**Stadium Concession Stand Replacement at
Leonardtwn High School
Bid Number: SMCPS-2024-10-DSS-DC**

**Addendum #1
April 25, 2024**

POWER CORD REEL

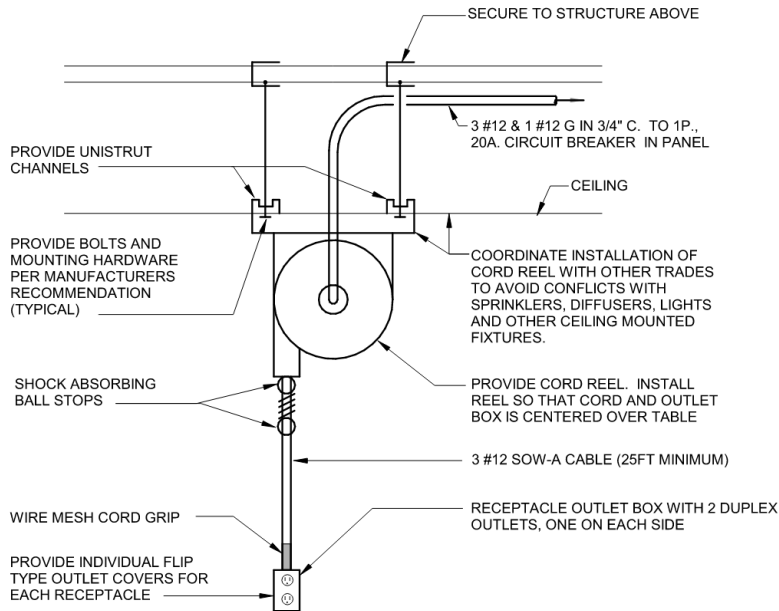
Q: Please provide a catalog or part number for the two cord reels in concession 100.

A: Legrand 1000 Series Cable Reel with In-Line GFI protection. Or approved equal.
